## Technical Memorandum

<b>Title</b>	Murdoch Drive Connection - Roundabout Analysis		
<b>Client</b>	City of Cockburn	<b>Project No</b>	CW1004500
<b>Date</b>	Prepared 17/10/2017	<b>Status</b>	Rev A
<b>Author</b>	Andrew Barry	<b>Discipline</b>	Civil Infrastructure and Property
<b>Reviewer</b>	Andreas Want	<b>Office</b>	Perth

### **RE: Murdoch Drive Cardno Assessment of MRWA Option 4**

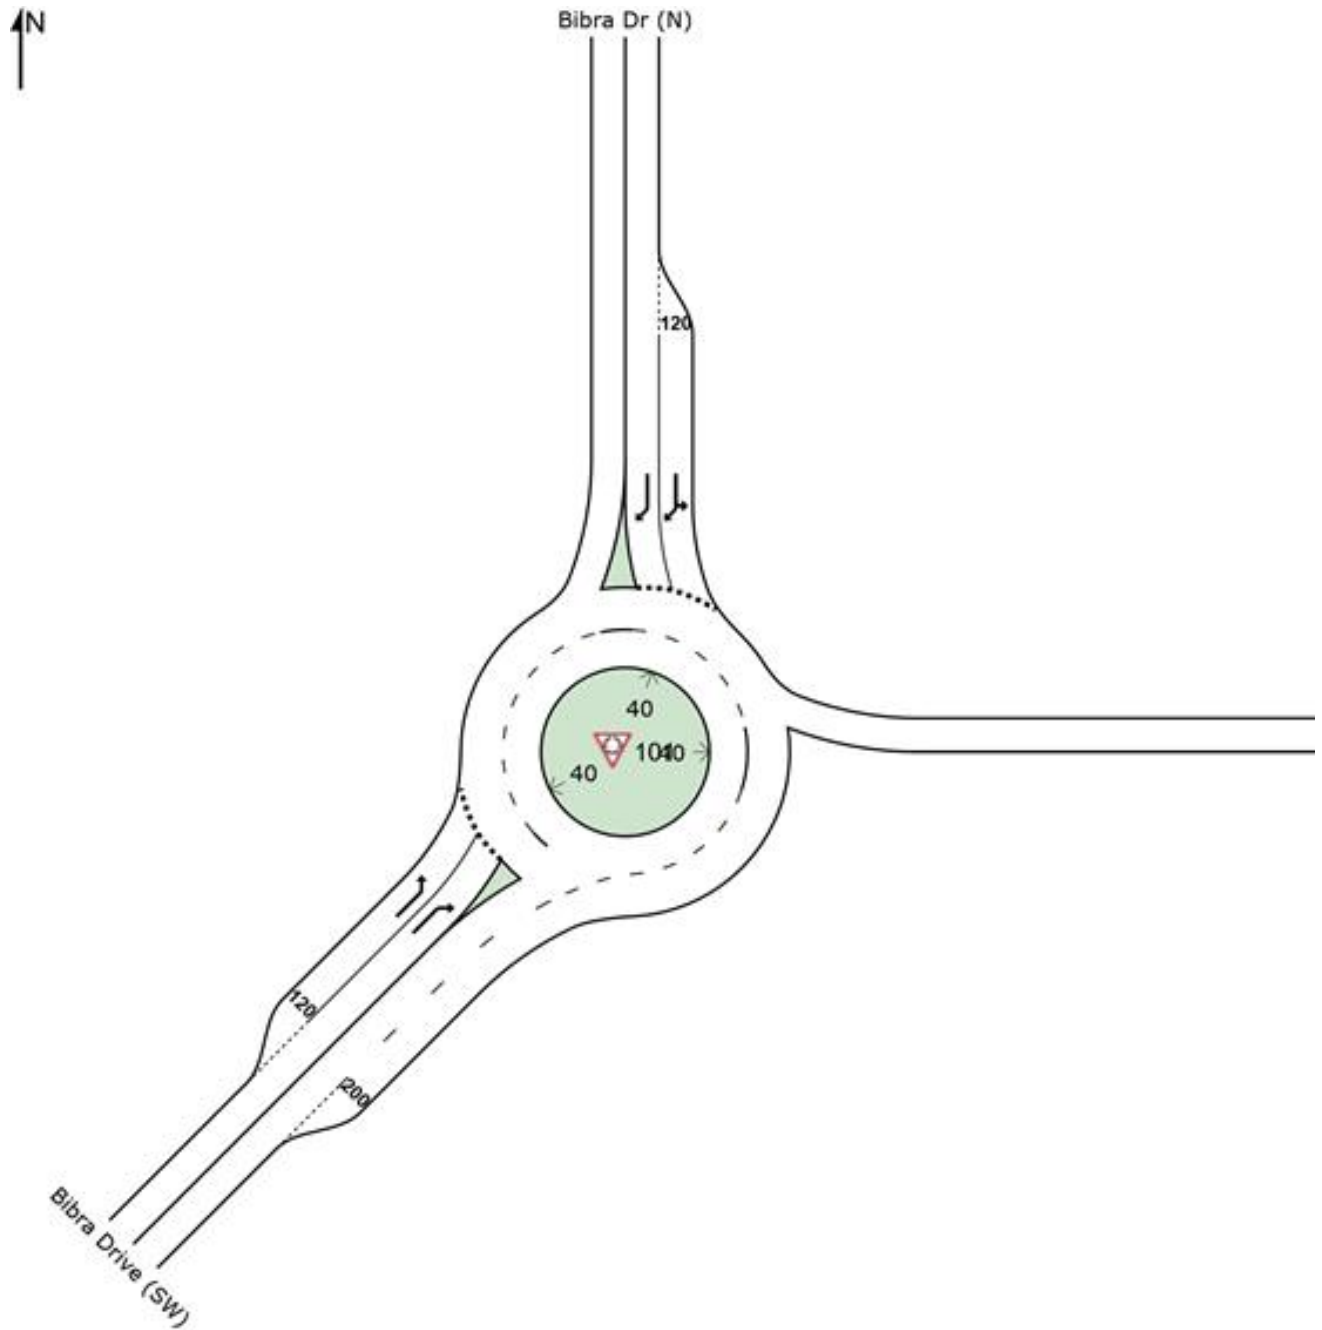
Findings

For the Bibra Drive / Hope Road roundabout, the analysis shows that this will operate with acceptable LOS for the 2021 scenarios, noting that the eastern approach is operating with higher-than-desired Degree of Saturation (DOS) for the 2021 PM scenario. However, for the 2031 PM scenario, the forecast growth in southbound traffic on Bibra Drive will not provide sufficient gaps in traffic for the eastern approach, resulting in queue lengths extending back to Roe Highway and a LOS of F.

Noting the low level of service provided by the current MRWA design, Cardno undertook further analysis on the Bibra Drive / Murdoch Drive Connection roundabout factoring improvements for the southbound approach and exit. This is represented graphically in the Sidra layout below.
